South Kerr Assembly Hall
TRC Review – Planning 8/6/19
Brian Chambers, 910.342.2782, brian.chambers@wilmingtonnc.gov

Site Plan:

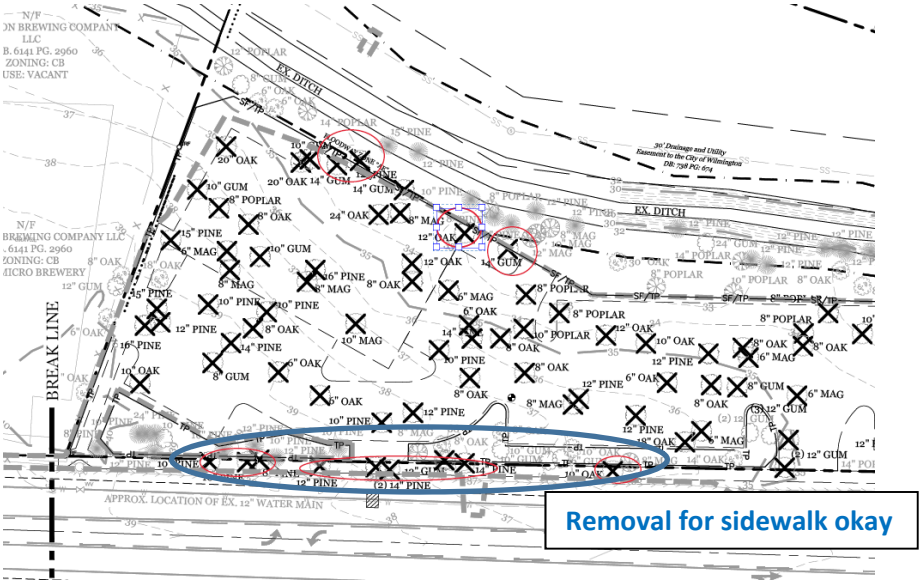
- Identify use on site plan as 'Assembly Hall.'
- Provide at least 216 square feet in landscape islands/peninsulas. Please label. *Previous comment.*
- A tree preservation/removal permit is required. See red line below. *Tree removal for sidewalk is okay.*
- Lighting shall not trespass onto or shine in the direction of the residentially used/zoned. Provide lighting plan (location/direction). *Previous comment.*
